City of Rockport

CITY COUNCIL REGULAR MEETING AGENDA

18. Consider the approval of Construction Change Directive #4 related to the new City Hall project

Consider the approval of Construction Change Directive #5 with Teal Construction related to the new City Hall project (cost pending)

SK-3C

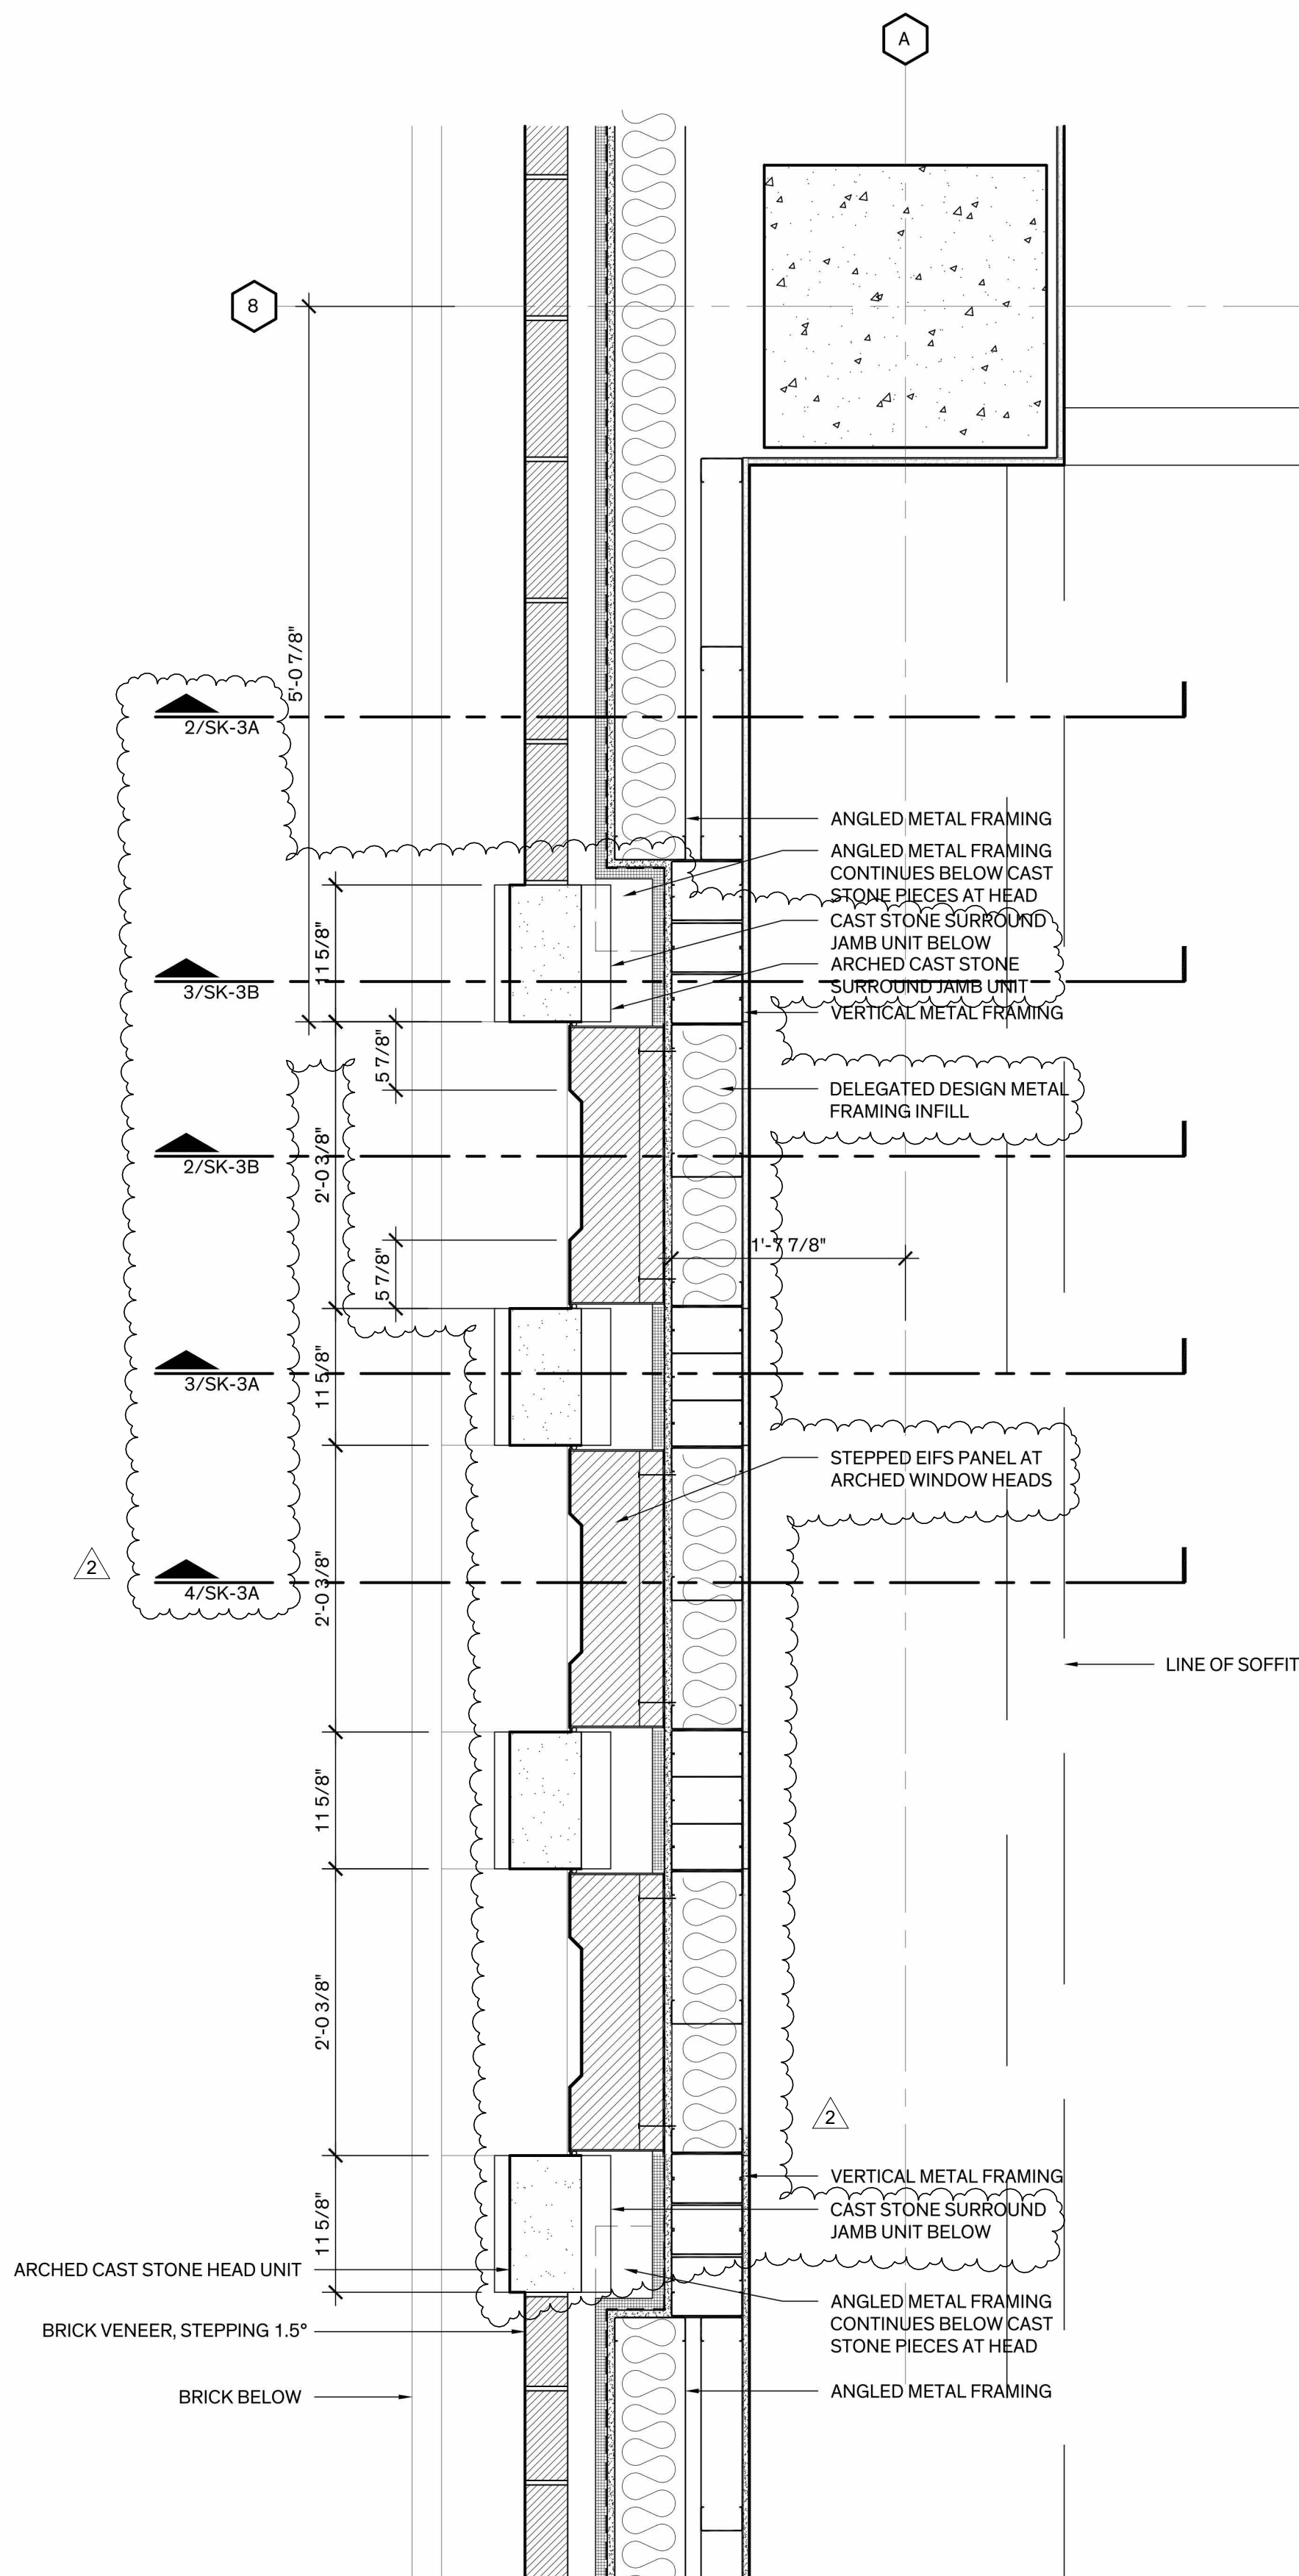
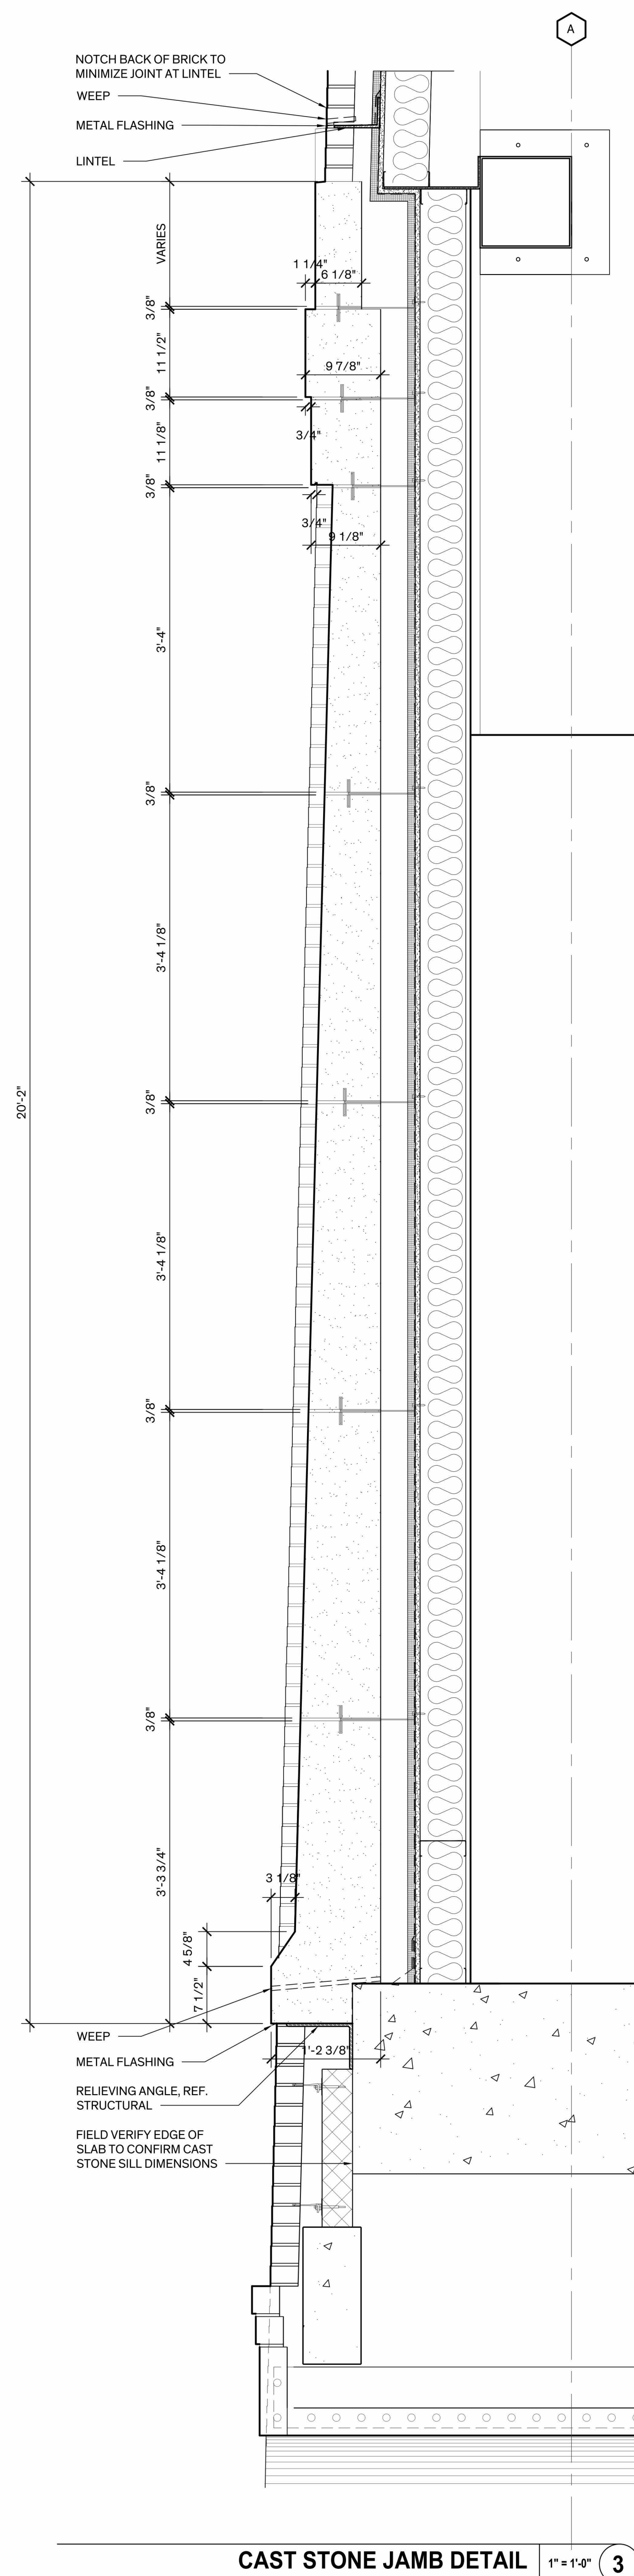
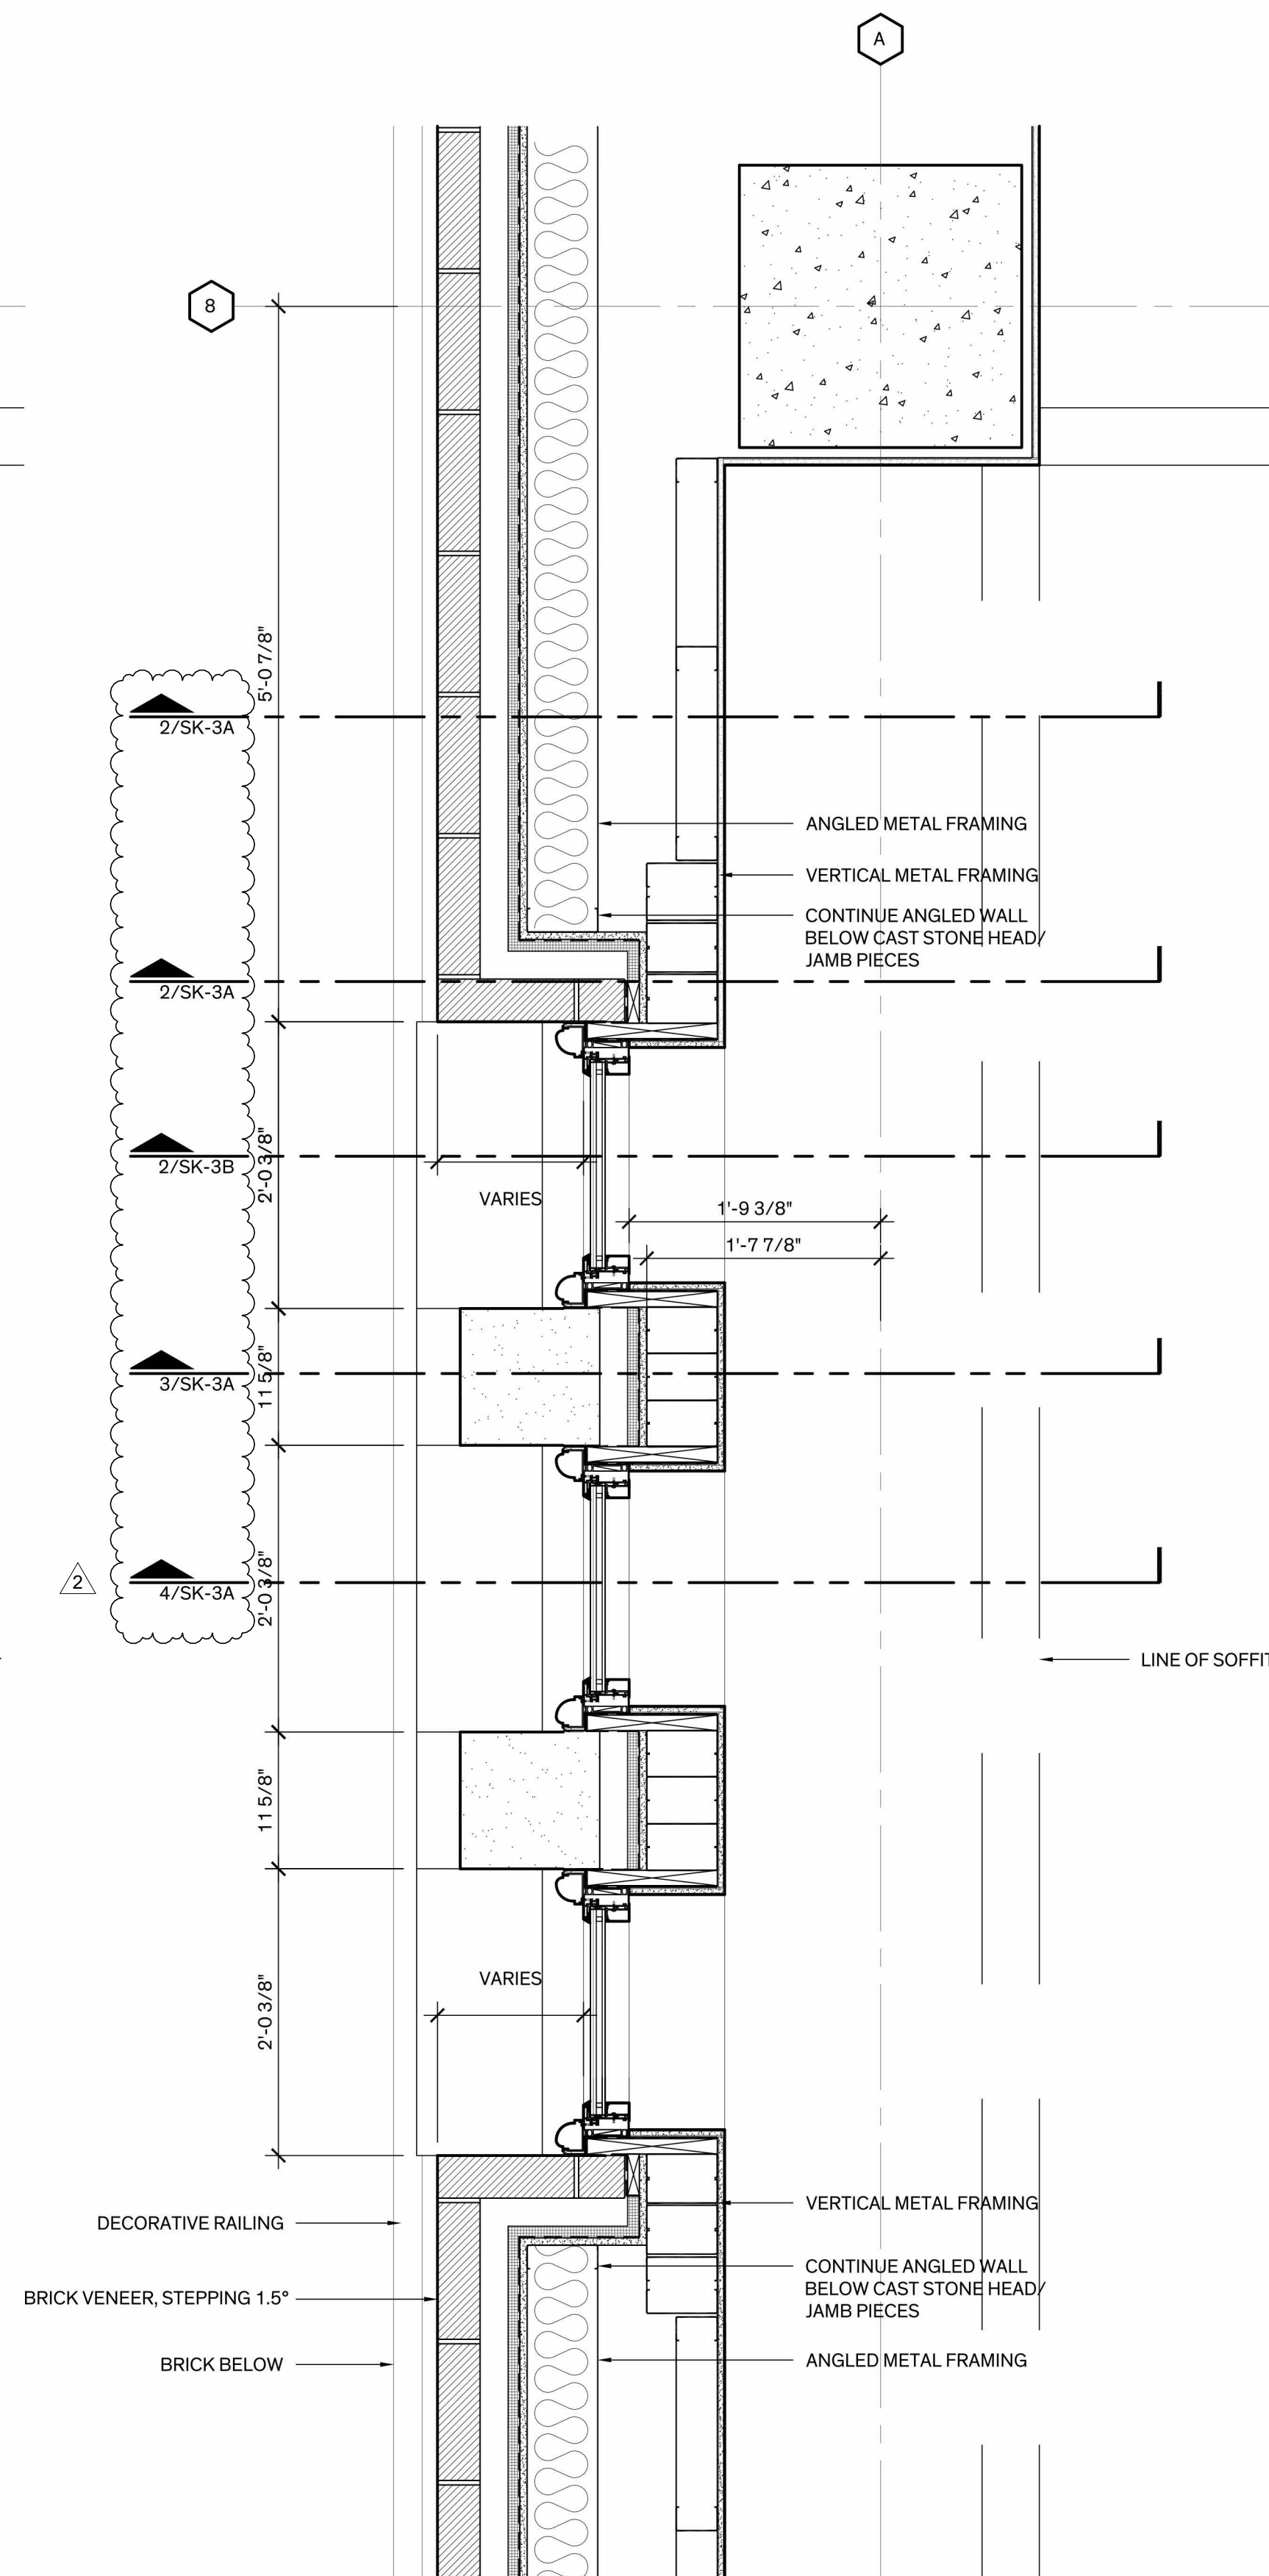
Special infill/reworking of as-built conditions is now required for areas that should have been incorporated with the surrounding metal framed walls per direction provided well in advance of metal framing installation. Had these changes been properly coordinated by the General Contractor, the change in material and labor would have been negligible, especially given the elimination of arched framed openings, etc. Teal is therefore responsible for all metal framing costs associated with this change request.

-The change from full height arched to reduced height rectangular windows with metal framed wall and decorative panels above was made during window shop drawing review dated 11/22/22. Teal did not coordinate the change with other affected subcontractors.

-The area was further documented in RFI 82 dated 2/7/23, see SK-3A through 3D.

-Architexas noted the missing framing and window head for the rectangular window openings in metal framing shop drawing review dated 2/22/23.

-Construction of metal framing and window openings proceeded in conflict with design team direction. Architexas noted the incorrectly built window framing in Field Report 12 from site visit on 1/3/24 and referred back to RFI 82.

-Teal continued construction of the tower exterior envelope and window openings with incorrect conditions and did not issue RFI 168 until 7/16/24.

-Teal did not coordinate the infill panels designed for the area above the rectangular windows (SK-1 provided 11/22/22 with window shop drawing review) and sequencing of surrounding construction. Infill panels needed to be coordinated prior to proceeding with waterproofing and finished masonry openings. Teal is responsible for all masonry removal and reinstallation required in this change request.

Provide EIFS infill with recessed panel detailing within arched openings above tower windows. Refer to attached revised SK-3A, SK-3B, SK-3C, SK-3D, and new SK-3E.

REMOVE
AS-BUILT TO REMAIN
INFILL REQUIRED AT EIFS PANELS
REINSTALL REMOVED COMPONENTS
